SUBJECT: INFORMATION ITEM--POTENTIAL DEFICIENCY IN THE SEISMIC
ANALYSIS OF EQUIPMENT AND COMPONENTS IN THE CONTAINMENT
ANNULUS OF DIABLO CANYON UNIT 1 (BOARD NOTIFICATION
NO. 81-47) *SGG RDP*

Enclosed are copies of PG&E's mark-up (copies denoted #1, #3, #4, and #5 and a copy of a marked-up section) of the earlier draft. Personnel

FIGURE 3.1: SEISMIC QUALIFICATION INTERFACES

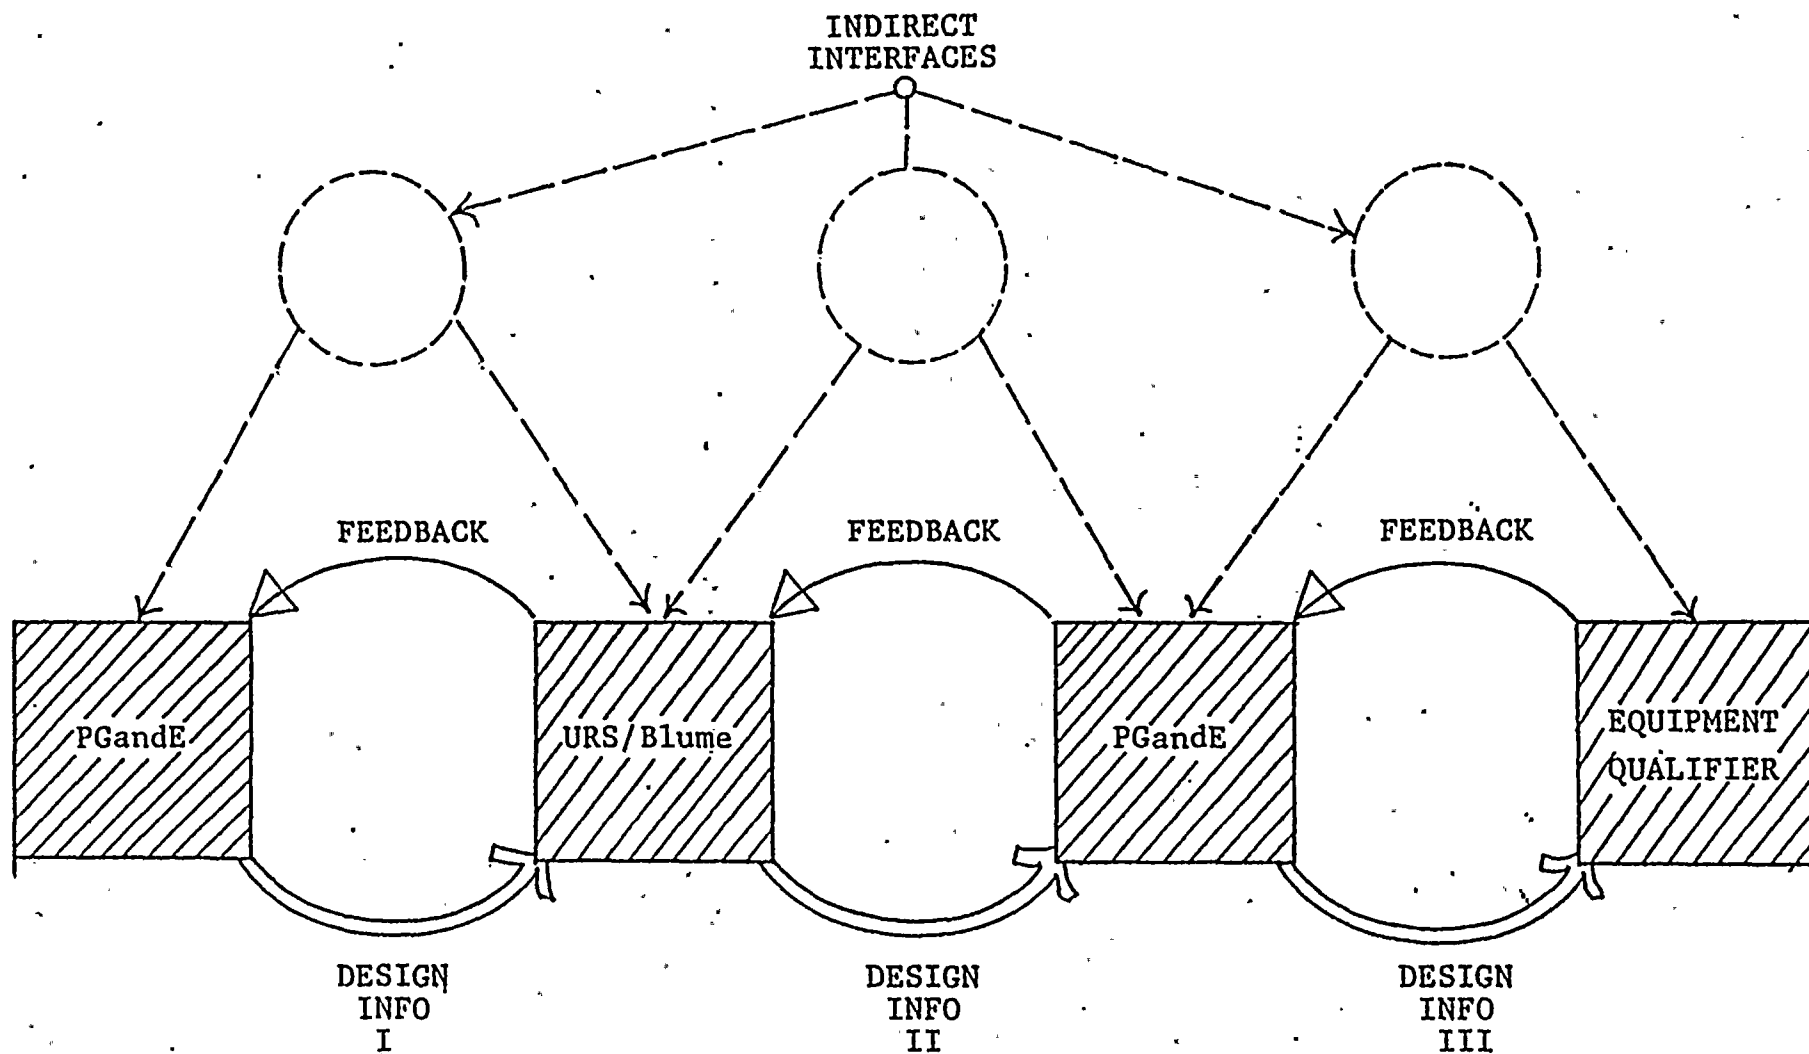
"Definition" of ground motion means
ground response spectra. It was based
on the combined efforts of Blume for PhdE

FIGURE 3.1: SEISMIC QUALIFICATION INTERFACES

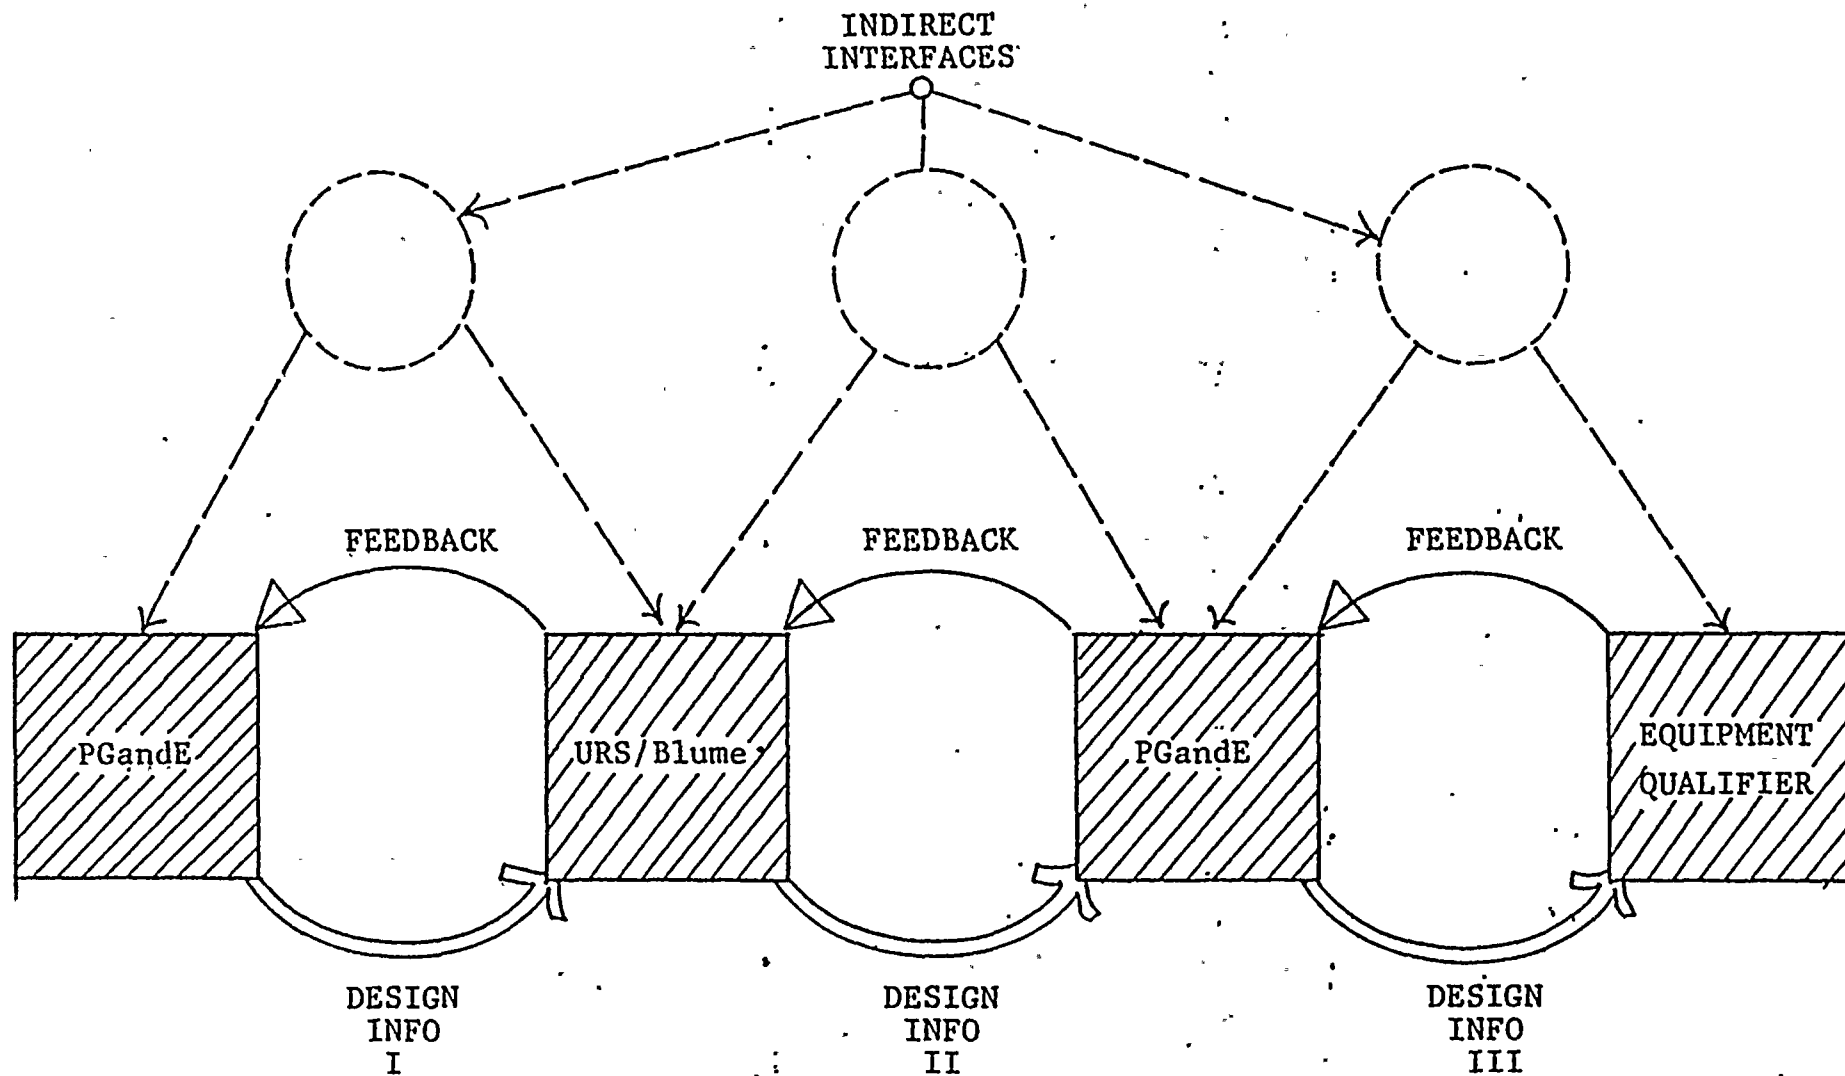
Interface I	Interface II	Interface III
Building Drawings Equipment Weights and C. G. Documentation of Verbal Discussion Definition of Ground Motion	Floor Response Spectra for all locations throughout plant Building Loads Dynamic Analysis Reports for all Buildings	Envelope Floor Spectra Static g Loads Equipment Specifications Test Specifications Purchase Orders <i>in-house use ?</i>
